INCH-POUND
MIL-A-18001J
AMENDMENT 2
13 March 1989
SUPERSEDING
AMENDMENT 1
7 December 1987

MILITARY SPECIFICATION

ANODES, CORROSION PREVENTIVE, ZINC;
SLAB DISC AND ROD SHAPED

This amendment forms a part of MIL-A-18001J, dated 25 November 1983, and is approved for use by all Departments and Agencies of the Department of Defense.

FIGURE 10. ZEP heat exchanger slab."

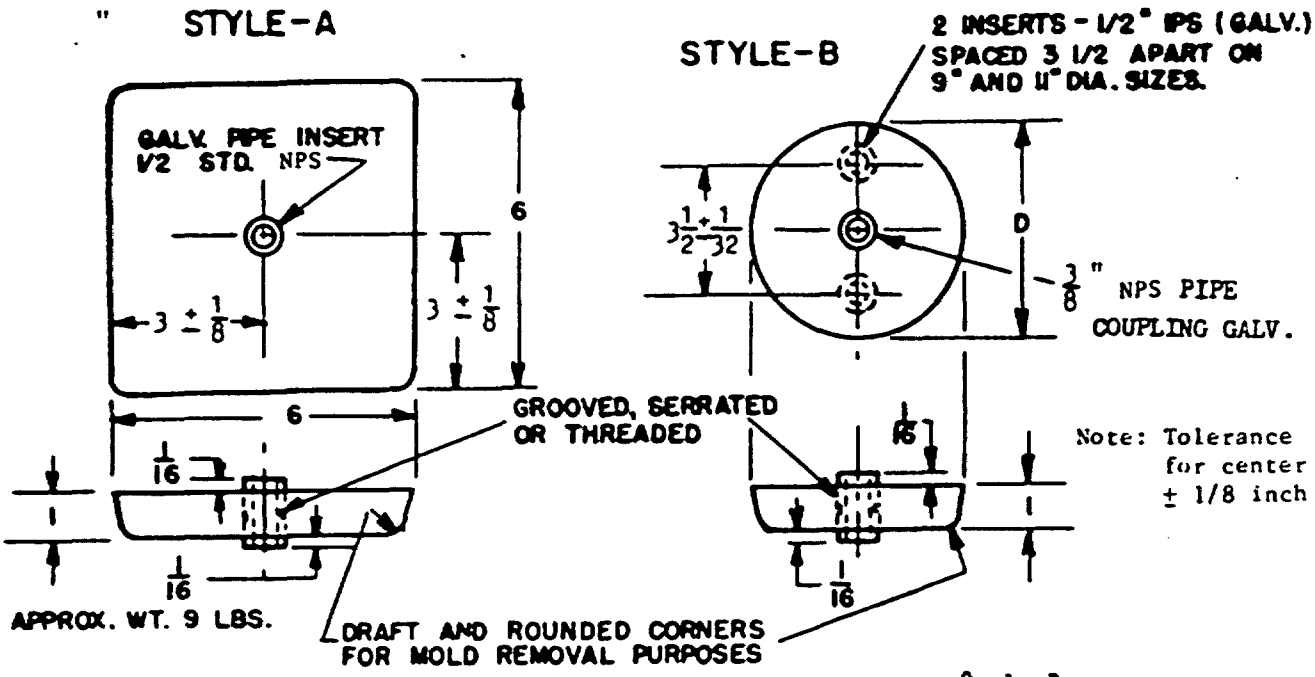
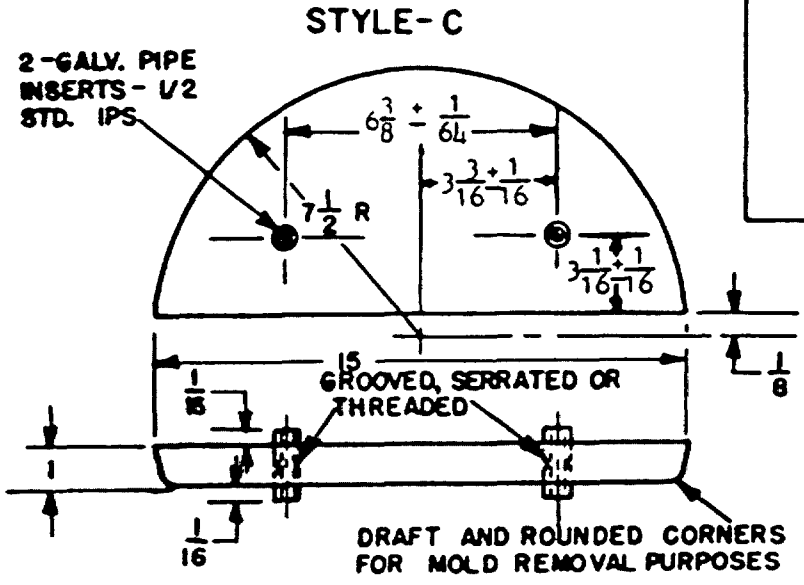
FIGURE 10: Delete and substitute.
